Access Compliance Report

Public Rights-of-Way (Curb Ramps)

Intersection ID: 10051	Main Street: LAKEDELL_DR	Cross Street: RUTH_DR	Location: NW
ADA ID: 48A2544E8B7B	Ramp Type: Perp	Initial Pass/Fail: Fail	Overall Compliance: No
Severity Score: 12.5			
Codes/Mitigation Info/Possible Solution		Field Measurements/Component Compliance

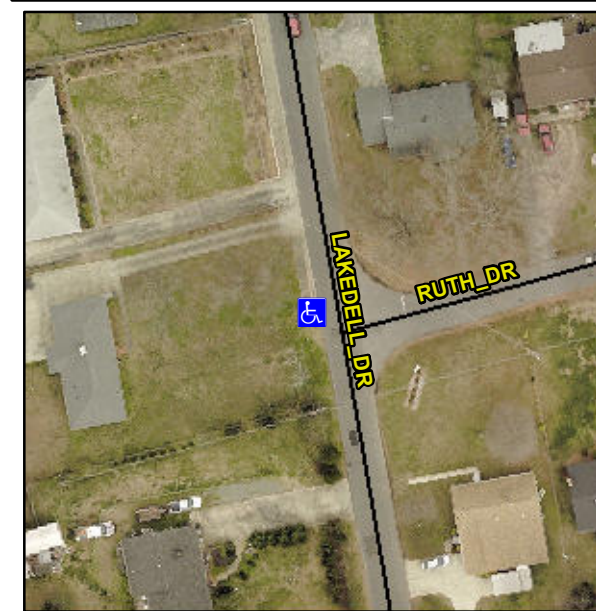
Not Found, R304.2.2

Compliance	Description	Data	Compliance	Description	Data
N/A	Ramp Length (in)	60.0	No	Ramp Slope (%)	9.6
Yes	Ramp Width (in)	88.0	Yes	Ramp XSlope (%)	1.6
N/A	Flare Type LT	N/A	N/A	Flare Type RT	N/A
N/A	Flare Slope LT (%)	N/A	N/A	Flare Slope RT (%)	N/A
N/A	Flare Traversable LT?	N/A	N/A	Flare Traversable RT?	N/A
N/A	Landing Length (in)	N/A	N/A	DWS Provided?	N/A
N/A	Landing Width (in)	N/A	N/A	DWS Contrast?	N/A
N/A	Landing Slope (%)	N/A	N/A	DWS Length (in)	N/A
N/A	Landing X Slope (%)	N/A	N/A	DWS Full Width?	N/A
N/A	Landing Curb? (Y/N)	N/A	N/A	DWS Offset (in)	N/A
N/A	Shared Landing?	N/A			
N/A	Gutter Ponding?	N/A	N/A	Gutter Slope (%)	N/A
N/A	Gutter Lip Ht (in)	1.0	N/A	Gutter X Slope (%)	N/A
N/A	Painted X Walk1?	No	N/A	Painted X Walk2?	N/A
	X Walk 1 Direction	To E		X Walk 2 Direction	N/A
N/A	X Walk 1 Width (in)	N/A	N/A	X Walk 2 Width (in)	N/A
	X Walk 1 Slope (%)	5.7		X Walk 2 Slope (%)	N/A
	X Walk 1 X Slope (%)	1.0		X Walk 2 X Slope (%)	N/A

Remove & Replace Entire Ramp.
